Discussion on 70/80 GHz Report & Order (FCC-03-248)

February 19, 2004

Wireless Communications Association International
Above 60 GHz Committee

Spectral Efficiency

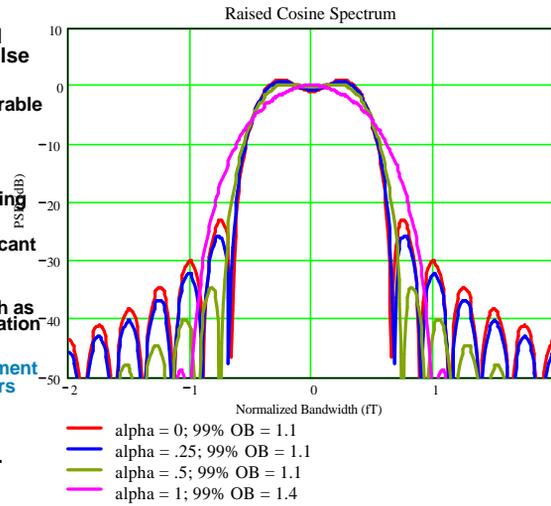
- The figure illustrates the spectral occupancy with raised cosine pulse shaping.
 - For low barrier to entry, it is desirable to implement simple modulation schemes.
 - The requirement of a minimum spectral efficiency of 1 bps/Hz prohibits the use of binary signaling such as OOK and BPSK.
 - Even QPSK would require significant pulse shaping to reduce the 99% occupied bandwidth.
 - If channel coding is desired, such as rate = 1/2, then high order modulation schemes would be required.
 - **Conclusion: the 1bps/Hz requirement is onerous for radio manufacturers**
- All simulation results presented herein assume completely co-channel and overlapping signals. Band segmentation has limited incremental value.

System Performance with Relaxed Antenna Requirements

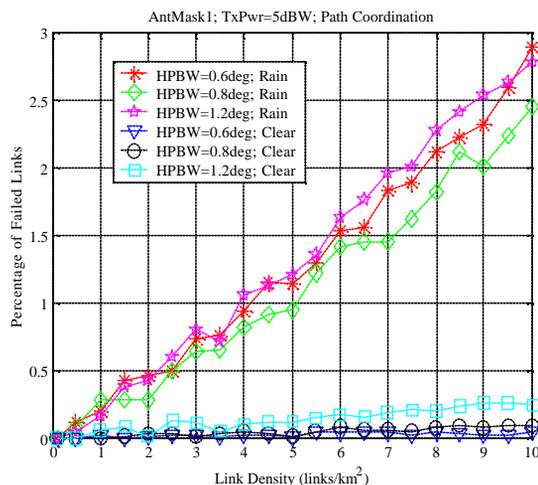
- This figure compares system performance with 0.6, 0.8, and 1.2 degree half power beamwidth for random deployments.
- System performance is comparable indicating that larger, higher gain antennas are not critical to high link density.
- Link ranges based on 99.99% availability, transmitter power identical for all cases
